UNITED STATES PATENT AND TRADEMARK OFFICE

APPLICATION NO.	FILING DATE	FIRST NAMED INVENTOR	ATTORNEY DOCKET NO.	CONFIRMATION NO.
10/006,621	12/10/2001	Hideyuki Takaoka	P 290437 OL98801N-US	1161

Office Action Summary

DETAILED ACTION

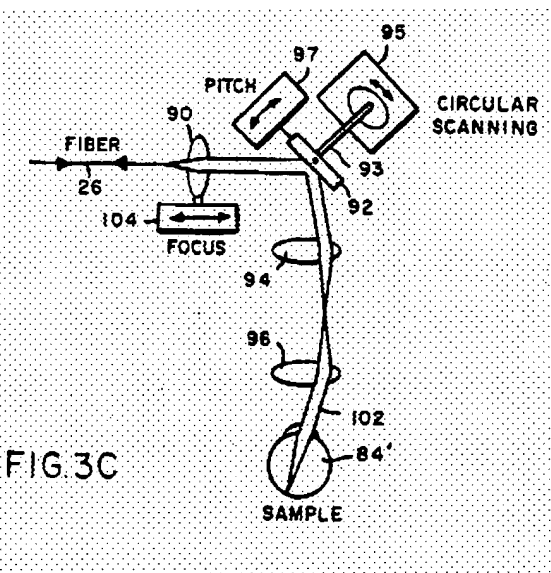
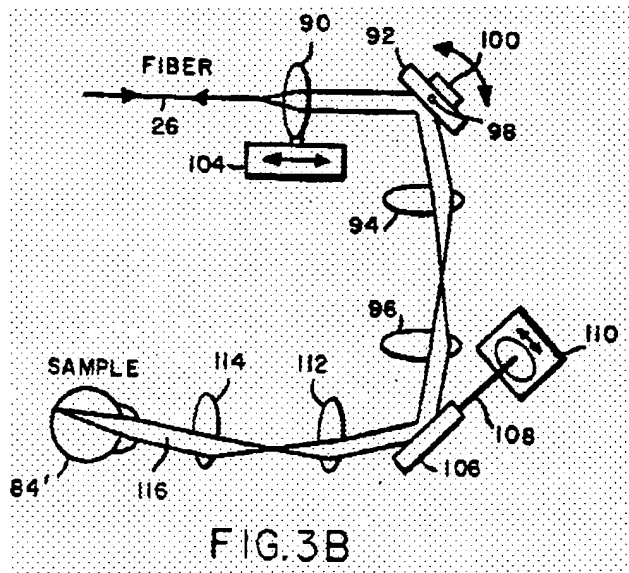
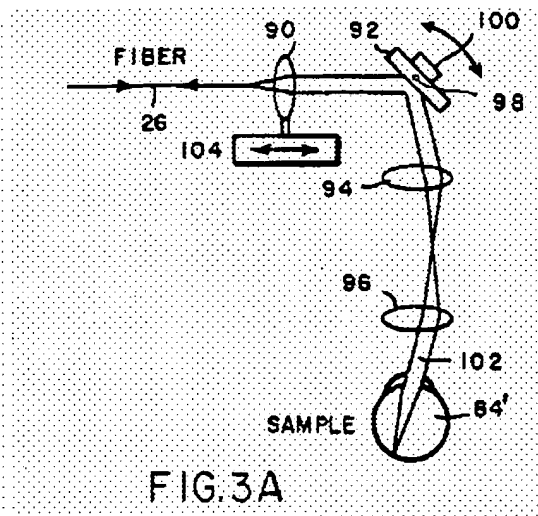
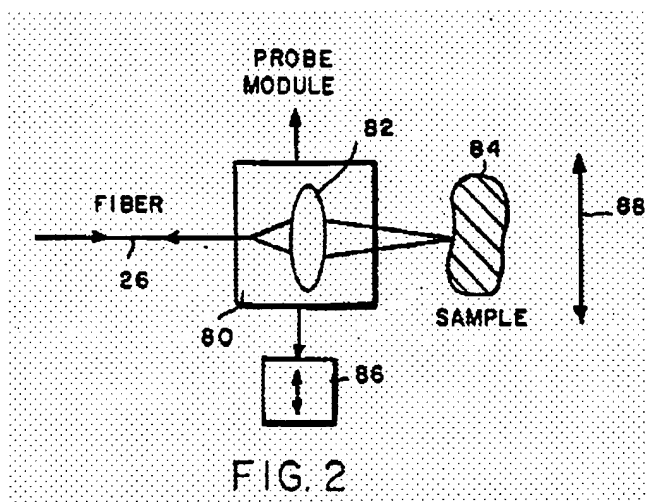
Claims 1, 2, and 5 are rejected under 35 U.S.C. § 102(b) as being clearly anticipated by Swanson et al(5,321,501).

Swanson teaches a coherence domain reflectometer comprising a short coherence light source(12); fiber coupler(22); a reference arm which includes AOM's(36,40), a path length scanner(42,46), and reference mirror(44); a measurement arm which includes a PZT phase modulator(34), and scan

mechanism(28); and photodetector(52). See figure 1A. Fiber/lens combinations change the diameter of the measurement beam. Also taught are multiple scanning arrangements including 1-3 dimensional scanning. See figures 2-3c. Figures 3a-4b also include pupil relays.

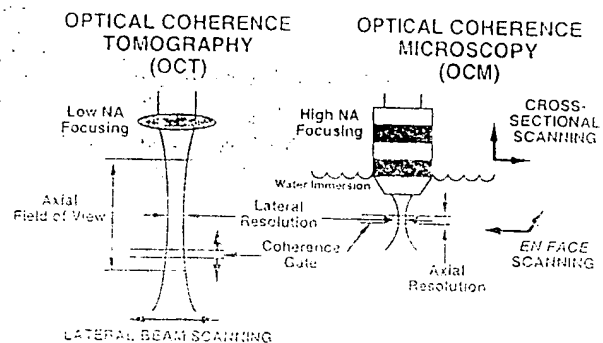
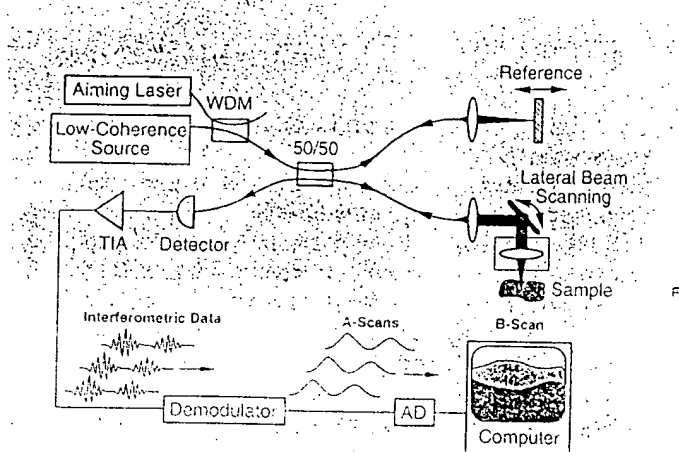
Claims 6-15, 17, and 19 are rejected under 35 U.S.C. § 103(a) as being unpatentable over Swanson et al(5,321,501) as applied to claims 3 and 4 above, and further in view of Izatt et al(Optics Letters).

Izatt et al teach that a low NA focusing objective can be used for OCT applications while a high NA focusing objective is used for OCM applications in a coherence domain reflectometer. See figures 1a and 1b.
